MECKLENBURG COUNTY
Land Use & Environmental Services Agency

MEMORANDUM

To: Charlotte-Mecklenburg Planning Commission
From: LUESA, Mecklenburg County
Date: 9.26.24
Subject: Rezoning Petition Comments

2024-100: 4000 Monroe Rd Rezoning

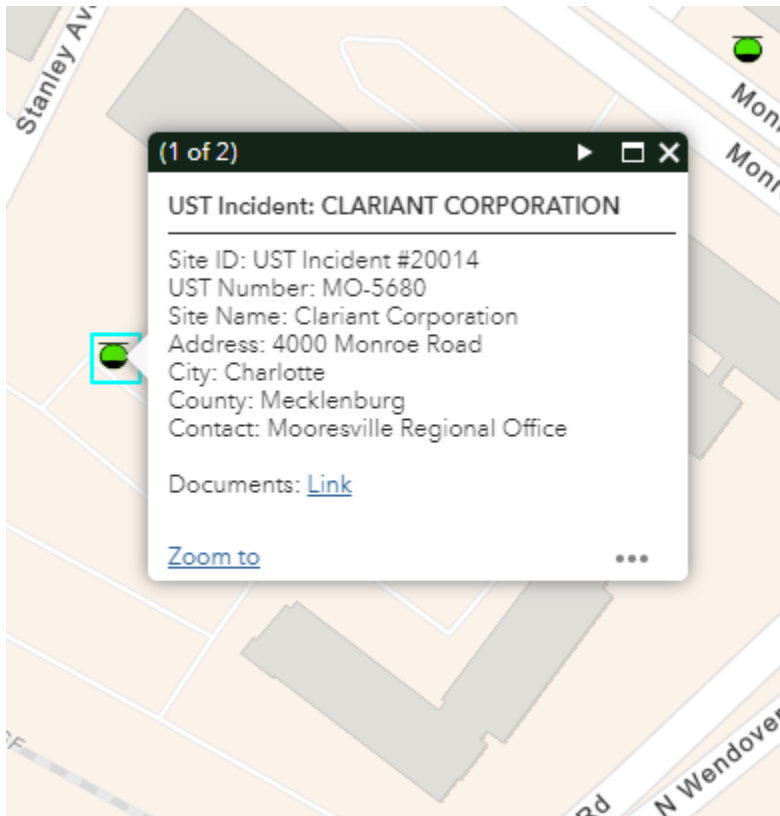
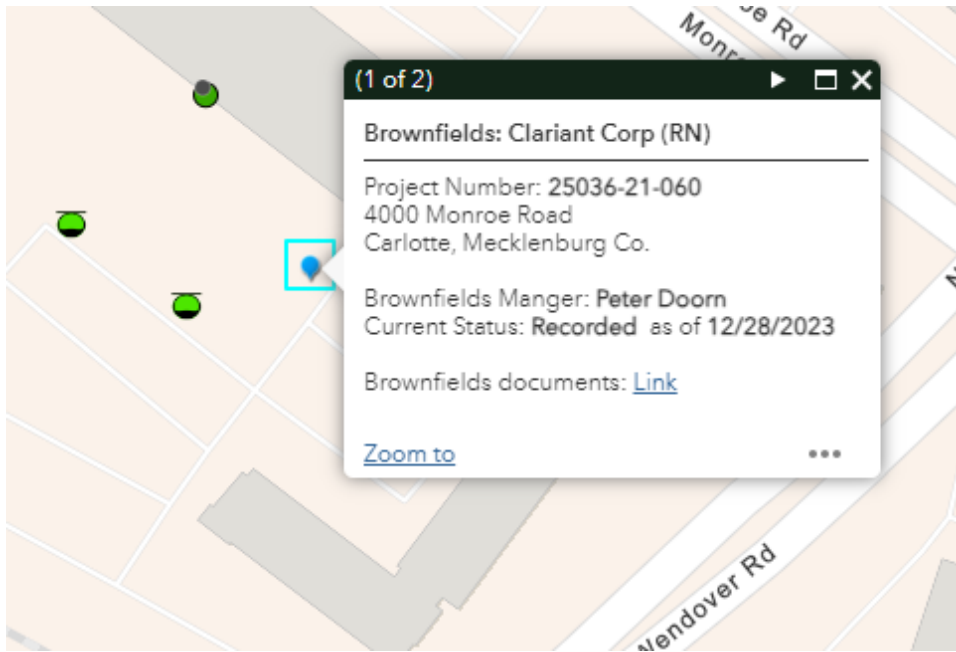
Contamination sites exist in the vicinity, so there may be restrictions for water supply wells. Contamination incidents are documented onsite. Fuel oil tanks and monitoring wells may exist at the property.

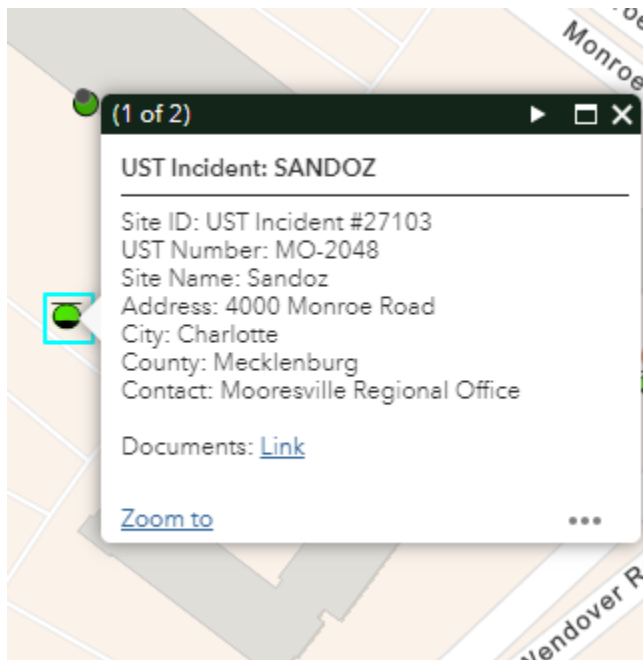
Groundwater & Wastewater Services records indicate contamination site(s) exist on or within 1,500 feet of the properties included in the petition. An established Area of Regulated Groundwater Usage (ARGU) as defined by the Mecklenburg County Groundwater Well Regulations extends 1,500 feet around the contamination sites. In an ARGU where municipally supplied water is available water supply wells for potable water supply, irrigation or open loop geothermal systems may not be permitted or constructed on or within 1,000 feet of contamination sites. Wells may be permitted with special construction and sampling requirements between 1,000 and 1,500 feet of contamination sites.
